**ORDINANCE NUMBER 2016-09**

**AN ORDINANCE OF THE TOWN OF PARADISE VALLEY,  
ARIZONA AMENDING THE PARADISE VALLEY ZONING  
ORDINANCE, Article XXII, HILLSIDE DEVELOPMENT  
REGULATIONS**

December 19, 2017 Draft Tack Changes

**FIGURE 3 — PRIMARY RIDGE LINE DESIGNATION**

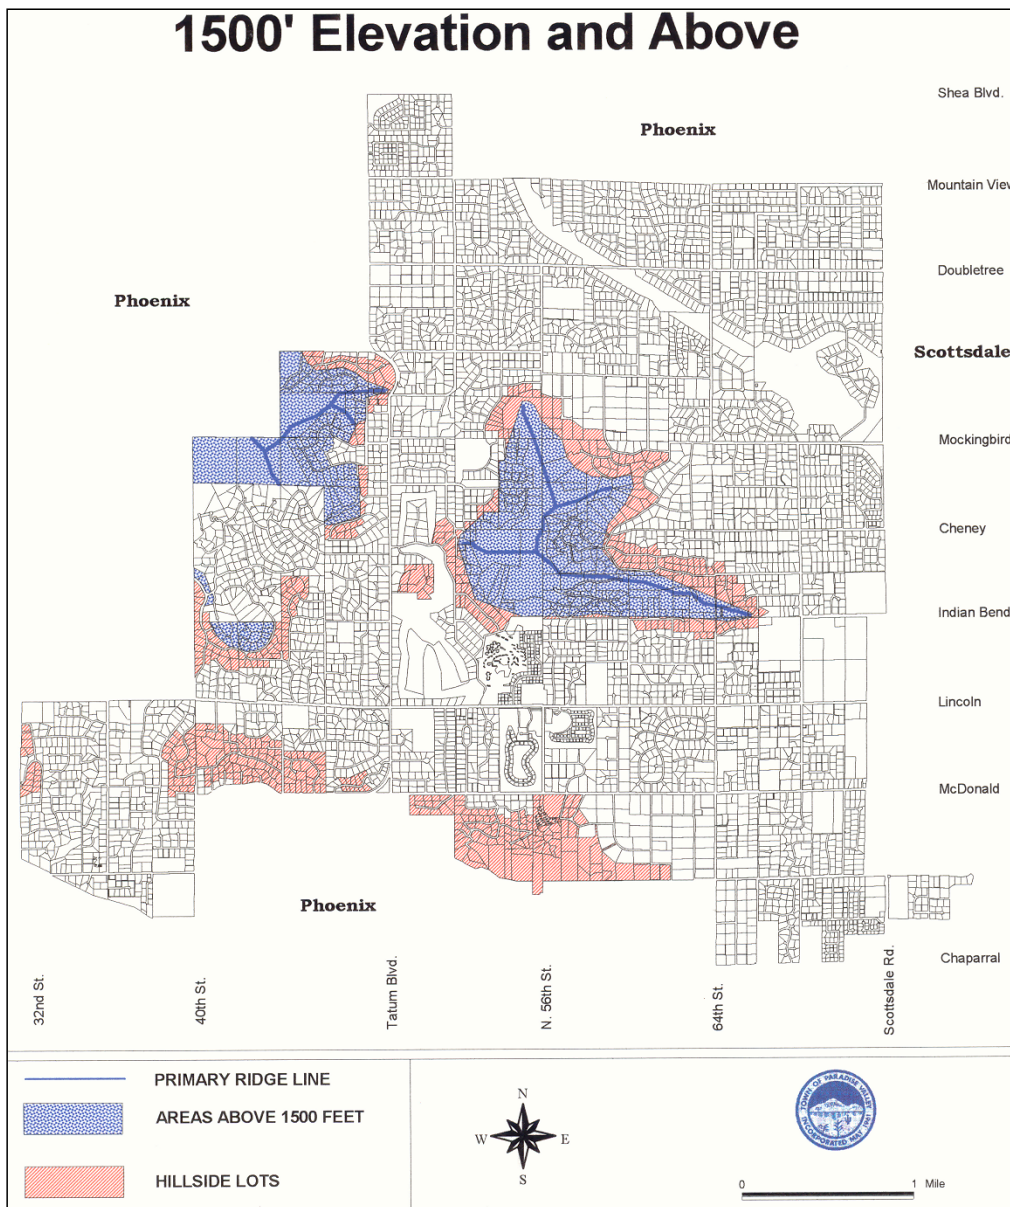
**Commented [GB1]:** Figure 3 Moved after Definition Section on Page 9

**FIGURE 5 – BUILDING HEIGHT IN HILLSIDE**

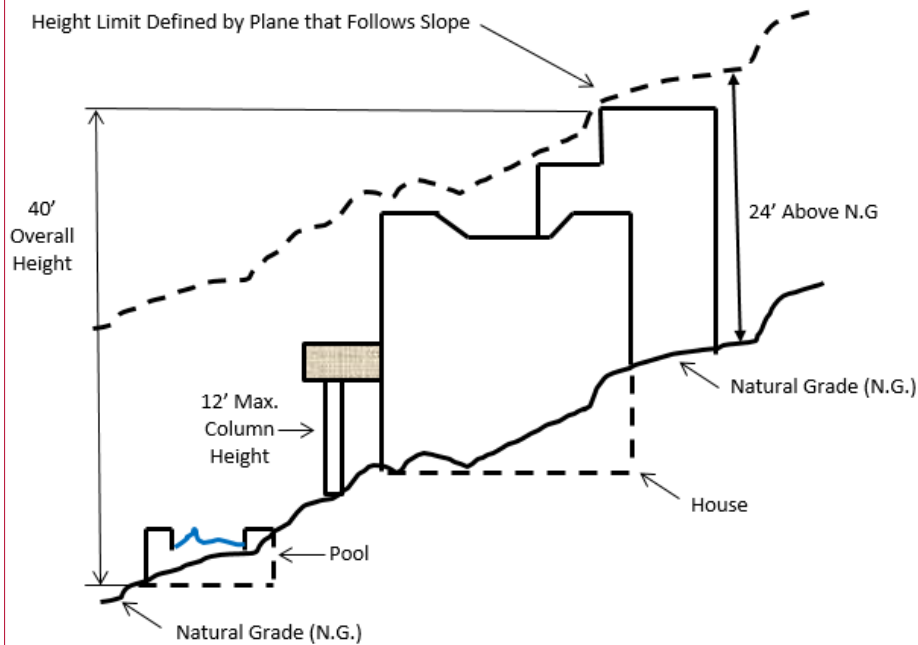
Commented [GB6]: 12/5/17 PC Review – Add arrows to the 40' height dimension

**FIGURE 5A – ACCESSORY BUILDING HEIGHT LIMIT**

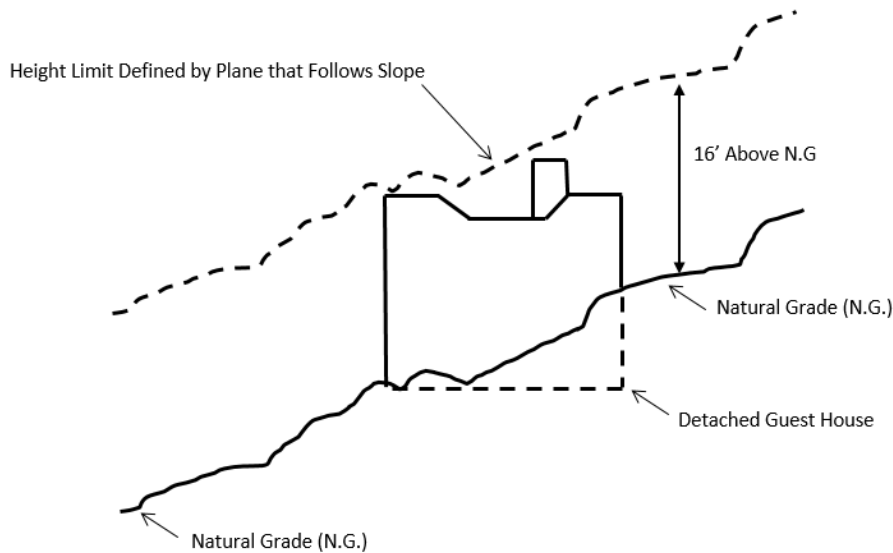
**ADD FIGURE ILLUSTRATING 16' HEIGHT LIMIT FIGURE 5a**

**FIGURE 5 – BUILDING HEIGHT IN HILLSIDE**

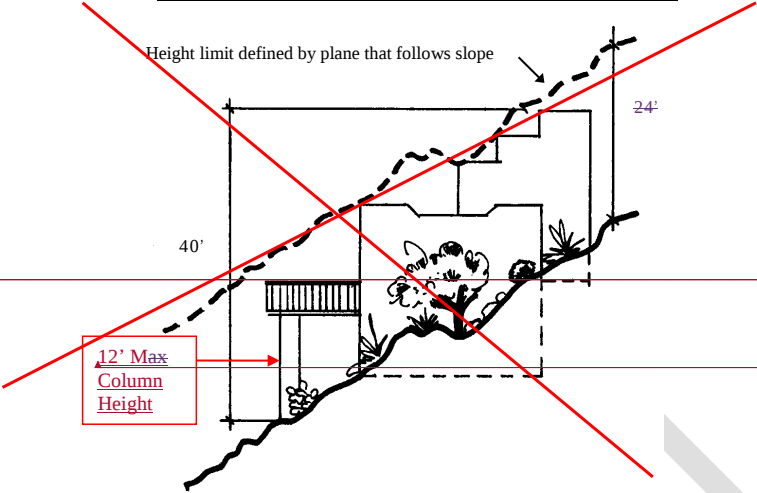
Commented [GB7]: Figure 5 to be updated to reflect these edits.

Commented [GB8]: Update Figure 5 to clarify measurement of 40' maximum height limit.

**FIGURE 7 - HEIGHT FOR A CANTILEVERED ELEMENT**

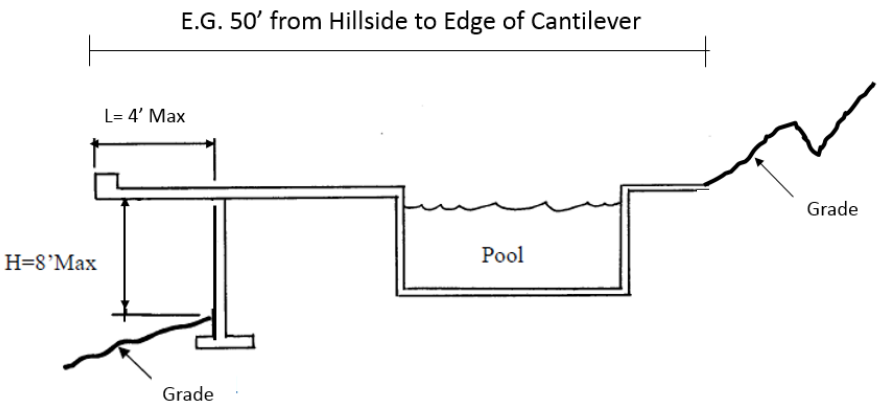
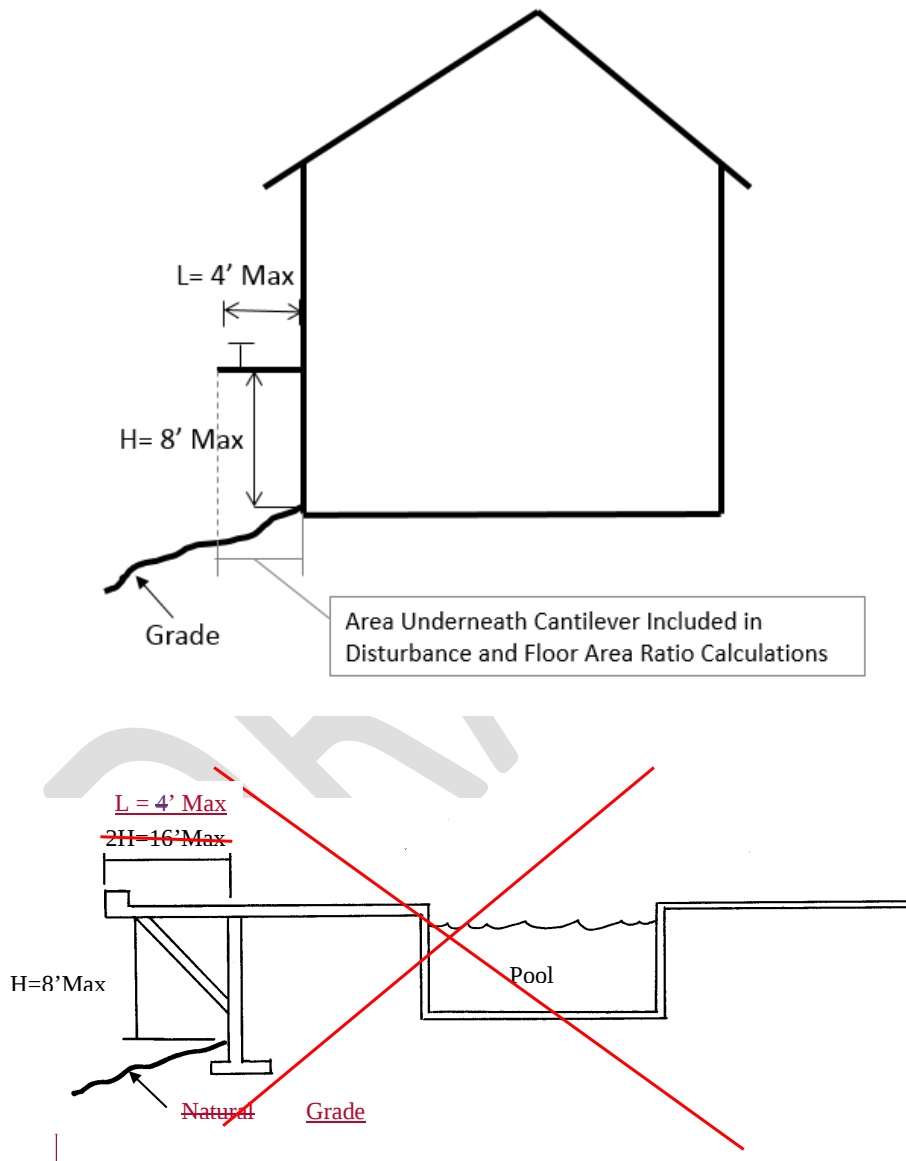
Commented [GB9]: New figures to be added to the code to illustrate these scenarios.

**FIGURE 8 TERRACED VERTICAL RETAINING WALLS**

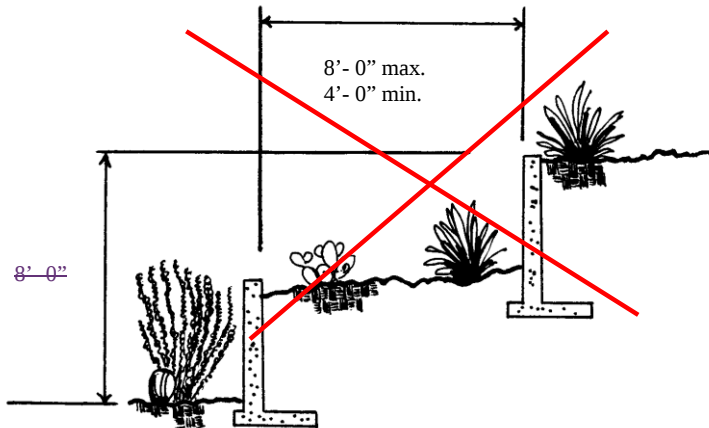
**Commented [GB14]:** Relocate Figure 8 below the text of 2207.VI.1.e.
